SERVICE BULLETIN

MTB-57-01

WINGS - INSPECT THE AFT UPPER AND LOWER WING BOLTS FOR CORRECT WASHER AND REPLACE IF NEEDED

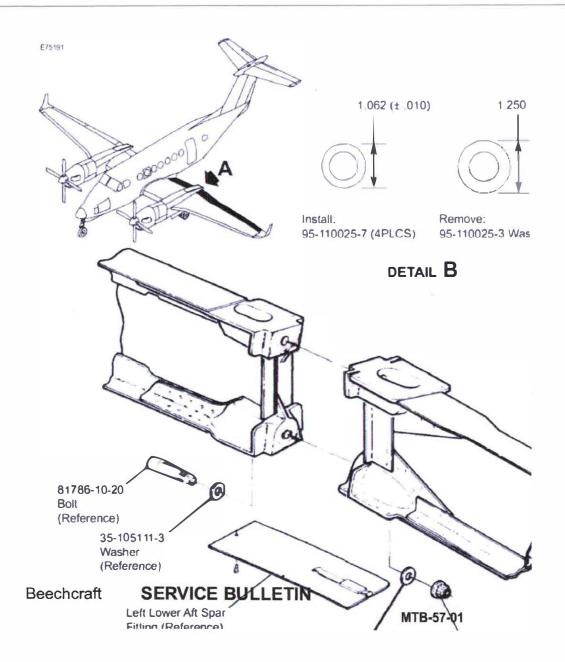
- (Refer to Figure 1, Sheet 1.) Examine the aft upper and lower wing bolls for the correct wing bolt washer as follows.
 - CAUTION: These inspections should be completed one attach-point at a time with the bolt installed and correctly torqued before moving to the next location. During removal the aft upper and lower wing bolts, make sure the wing is supported in a manner which will prevent the possibility of movement of the upper-attach fittings.

- Remove the left upper and lower aft spar bolts.
 - B. Determine if a 95-110025-7 Washer is installed at the shown position on 81786-10-20 bolt.
 - (1) If a 95-110025-7 Washer is installed, no further action is required. Go to Step 3.

- (2) If a 95-110025-7 Washer is not installed, go to Step 2.C.
 - C. Remove the 81786-10-20 Bolt and remove the 95-110025-3 Washer from the bolt.

- E. Install a new 95-110025-7 Washer on the 81786-10-20 Bolt. (Refer to King Air Structural Inspection and Repair Manual, Chapter 57.)
- Install the left upper and lower aft spar bolts.
